CITY OF ALBUQUERQUE

Re: WYNDHAM HOTEL RENOVATIONS (PHASE 1, NO SITE WORK)
2500 Carlisle Blvd NE
60-Day Temporary Certificate of Occupancy
Transportation Development Final Inspection
Engineer's/Architect's Stamp dated 12-18-18 (AA) (H17D002)
Certification dated 5-14-20

18007
AS102.2

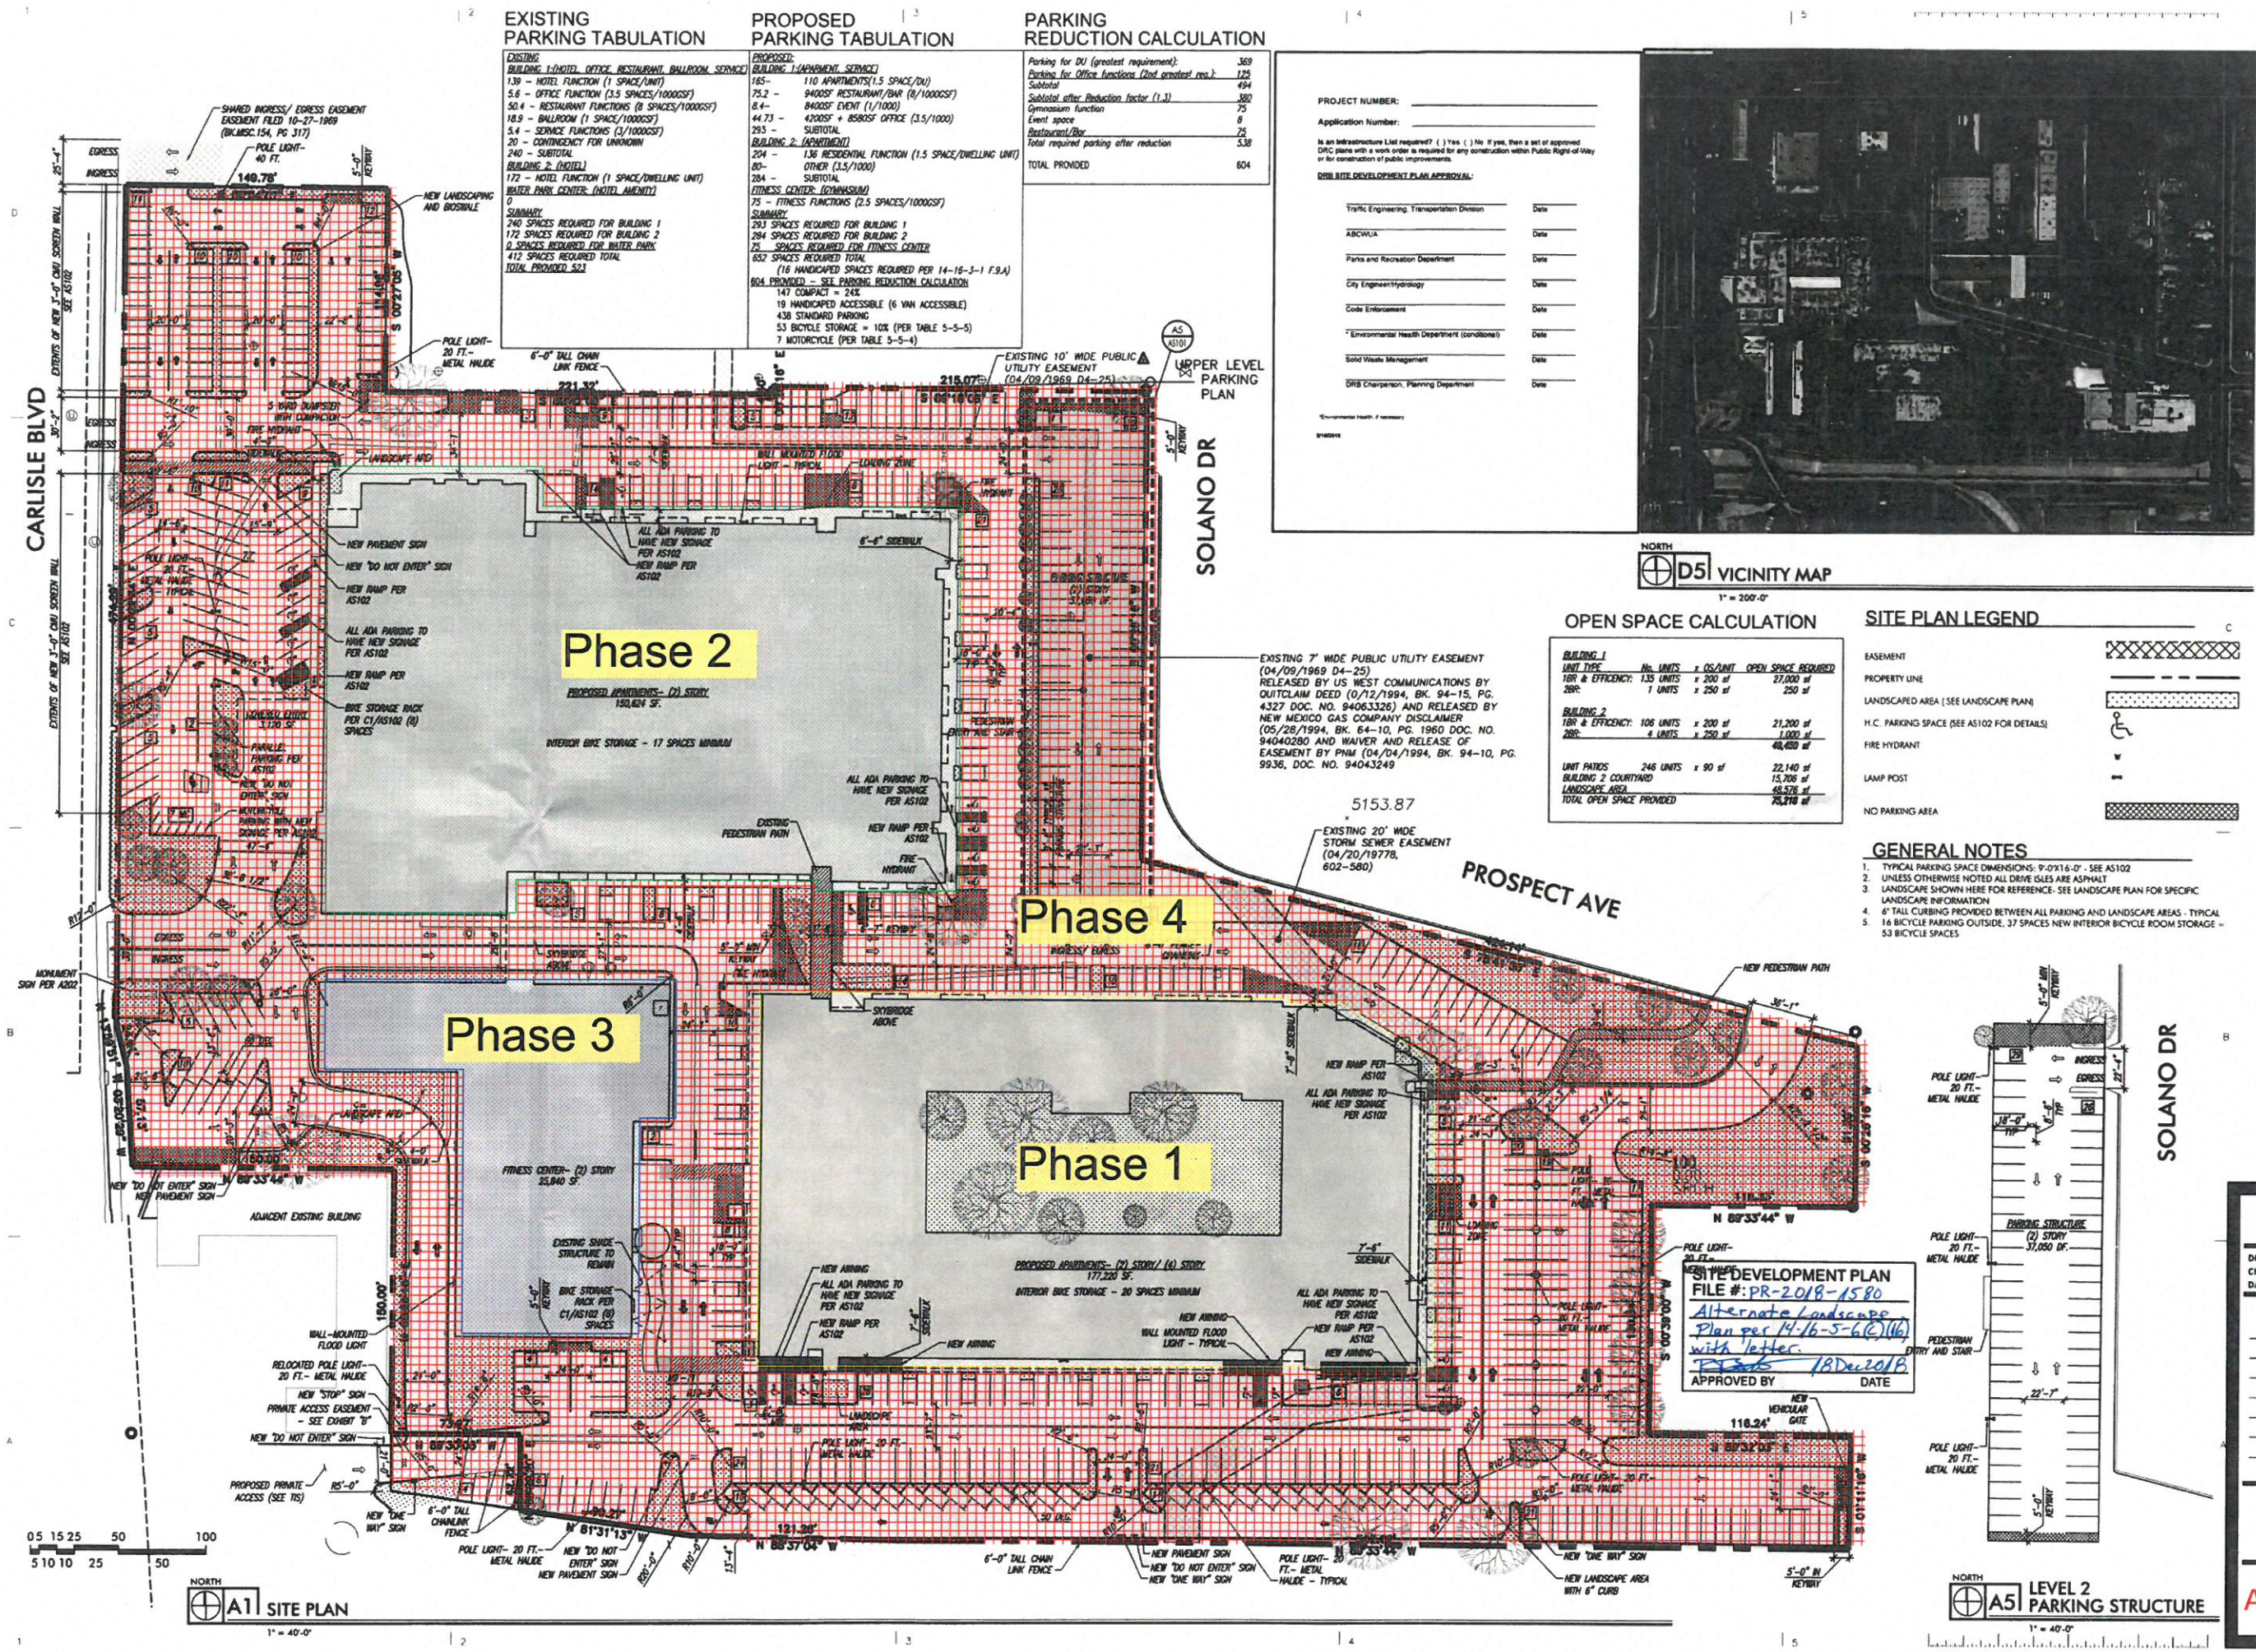
Prior to the issuance of a permanent Certificate of Occupancy, the following items must be addressed:

- Completion of Phase 4.

Once Phase 4 is complete resubmit

1. The approved and stamped Administrative Amendment with changes drawn in red.
2. Transportation Certification letter on either the plan or applicants letterhead.
3. A Drainage Transportation Information Sheet (DTIS)
4. Send an electronic copy of your submittal to PLNDRS@cabq.gov.
5. The \$110.00 submittal fee for log in and evaluation by Transportation.
